Access Compliance Report

Public Rights-of-Way

(Curb Ramps)

Intersection ID: 2778	Main Street: HIGHLAND_CREEK_PY	Cross Street: BRADWELL_DR	Location: E
ADA ID: 7F13E6AEB9FF	Ramp Type: PerpDiag	Initial Pass/Fail: Fail	Overall Compliance: No
Severity Score: 33.75			
Codes/Mitigation Info/Possible Solution		Field Measurements/Component Compliance

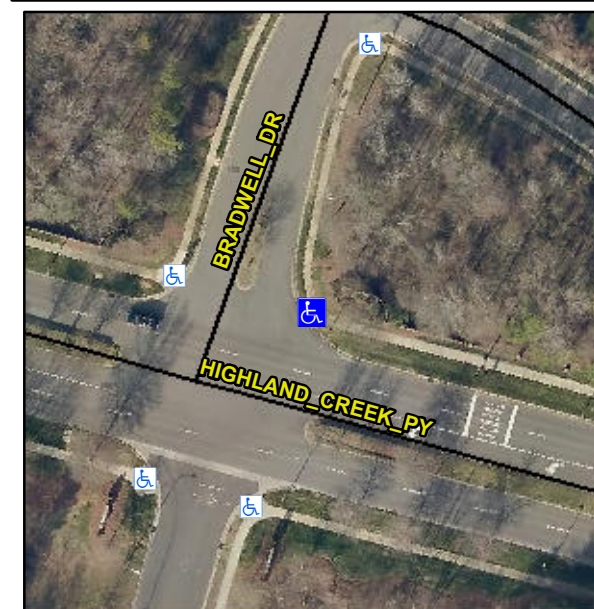
R304.5.1, R304.2.2, R304.5.3

Compliance	Description	Data	Compliance	Description	Data
N/A	Ramp Length (in)	50.5	No	Ramp Slope (%)	10.3
No	Ramp Width (in)	43.5	No	Ramp XSlope (%)	6.6
N/A	Flare Type LT	N/A	N/A	Flare Type RT	N/A
N/A	Flare Slope LT (%)	N/A	N/A	Flare Slope RT (%)	N/A
N/A	Flare Traversable LT?	N/A	N/A	Flare Traversable RT?	N/A
N/A	Landing Length (in)	N/A	N/A	DWS Provided?	N/A
N/A	Landing Width (in)	N/A	N/A	DWS Contrast?	N/A
N/A	Landing Slope (%)	N/A	N/A	DWS Length (in)	N/A
N/A	Landing X Slope (%)	N/A	N/A	DWS Full Width?	N/A
N/A	Landing Curb? (Y/N)	N/A	N/A	DWS Offset (in)	N/A
N/A	Shared Landing?	N/A			
N/A	Gutter Ponding?	N/A	N/A	Gutter Slope (%)	N/A
N/A	Gutter Lip Ht (in)	N/A	N/A	Gutter X Slope (%)	N/A
N/A	Painted X Walk1?	No	N/A	Painted X Walk2?	No
	X Walk 1 Direction	To NW		X Walk 2 Direction	To SW
N/A	X Walk 1 Width (in)	N/A	N/A	X Walk 2 Width (in)	N/A
	X Walk 1 Slope (%)	1.5		X Walk 2 Slope (%)	8.4
	X Walk 1 X Slope (%)	7.2		X Walk 2 X Slope (%)	3.3

N/A	Ramp inside XWalk1?	N/A	N/A	Ramp inside XWalk2?	N/A
	Road Slope (%)	6.2	N/A	Clear Space?	N/A
	Road X Slope (%)	6.9	N/A	Clear Space to XWalk (in)	N/A
N/A	Any Obstructions?	N/A	N/A	Storm Grate/Utility Hazard?	N/A
	Obstruction Type			Storm Grate/Utility Type	
		N/A			N/A
			Yes	Surface Condition? (G/P)	Good

Remove & Replace Curb Ramp With Two New Directional Ramps or Equivalent.
